To: Town of Lewisboro Planning Board

From: Paul Lewis

Date: February 23, 2014

Re: **Petrucelli Application** for subdivision and wetland permit
Oscaleta Road, South Salem, NY

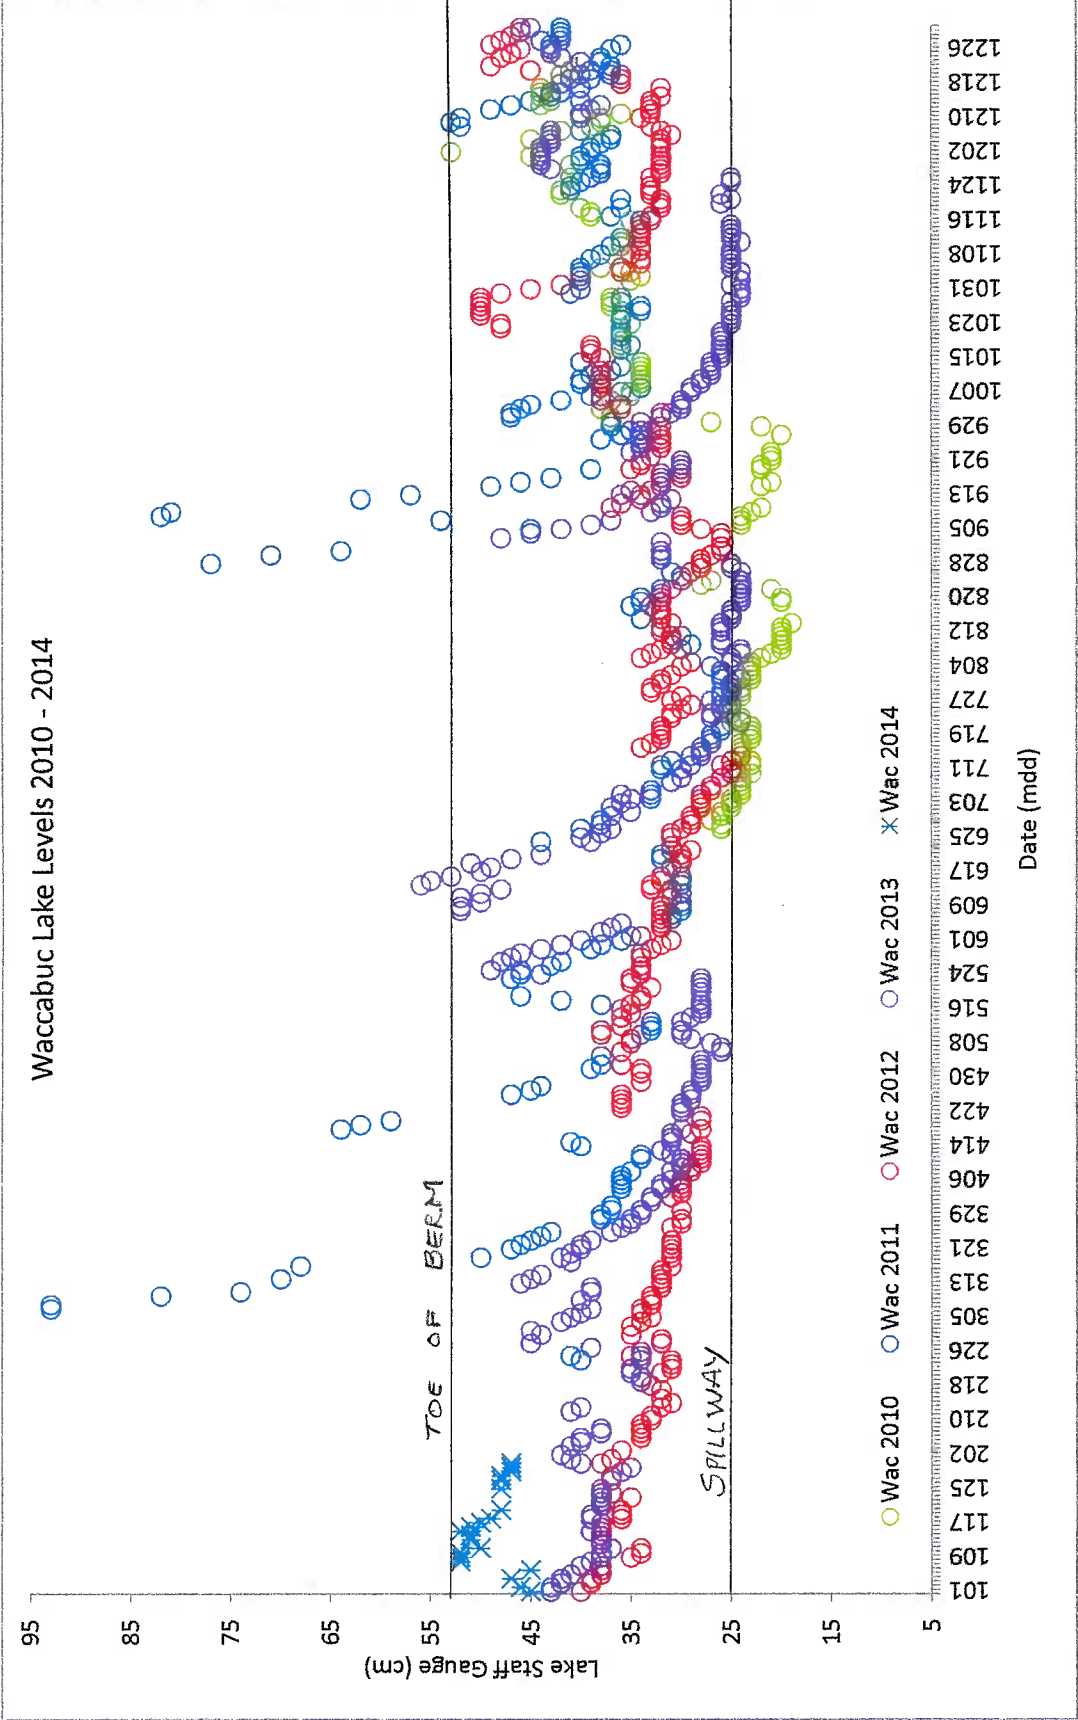
Further, we determined that the plans show an error of about 1.5' in the relationship between the level of the land and the level of the lake. That is, the plans show the land to be 1.5' higher than our measurements relative to the lake. We confirmed this by working from a spot elevation on the Three Lakes Council property that shows on the plans. I recommend all this these levels be professionally surveyed.

As you know, the Three Lakes Council has been monitoring lake water levels for the past 3-1/2 years which Jan Andersen plotted on the attached graph. This graph shows that the water reaches the berm about twice per year on average, and considerably exceeds that by a foot or more every couple of years. Knowing that there can be over a 2' foot variation in lake levels, it is critically important that the topography be accurately represented, especially since septic fields don't function properly in flooded soils. With the wetlands being flooded and the water lapping up against the berm at times, phosphorus from the septic system will get into the lake more readily than the applicant leads one to believe.
